RE: **37-DR-2021**
Hazel & Azure - Camelback
79P54 (Key Code)

The Planning & Development Services Division has completed the review of the above referenced development application submitted on 9/17/2021. The following **1st Review Comments** represent the review performed by our team and is intended to provide you with guidance for compliance with city codes, policies, and guidelines related to this application.

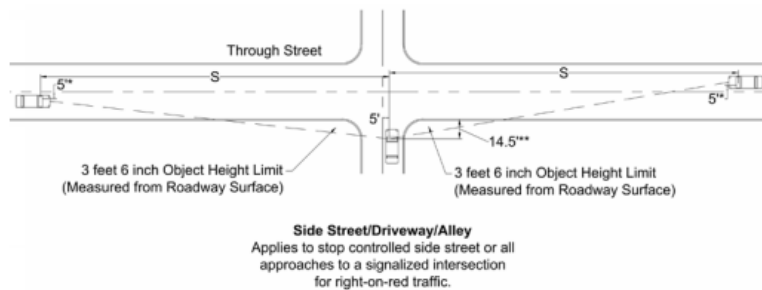
40. DSPM. 2-1.305 F. Provide loading and unloading areas, minimum length of 45’ and width of 12’, in accordance with below tables, update site plan accordingly. Alleys, fire lanes and streets shall not be used for loading and unloading.

MULTI-FAMILY OFF-STREET LOADING & UNLOADING AREAS	
NO. OF DWELLING UNITS	NO. OF LOADING & UNLOADING AREAS
0 -50	1*
51 - 150	1
151 - 450	2
OVER 450	3**
* The DRB may approve designating one on-lot parking space for loading and unloading that is 10 feet wide by 18 feet long. Designated spaces shall be signed and striped as loading and unloading areas.

** Plus, any additional loading areas required by the DRB.	
NON-RESIDENTIAL OFF-STREET LOADING & UNLOADING AREAS	
GROSS FLOOR AREA (FT ²)	NO. OF LOADING & UNLOADING AREAS
LESS THAN 30,000	1*
30,001 TO 100,000	1
100,001 TO 200,000	2
OVER 200,000	3**

* For each 10,000 square feet of gross floor area of a development project, the DRB may approve designating one on-lot parking space for loading and unloading that is 10 feet wide by 18 feet long. Designated spaces shall be signed and striped as loading and unloading areas.

** Plus, any additional loading areas required by the DRB.
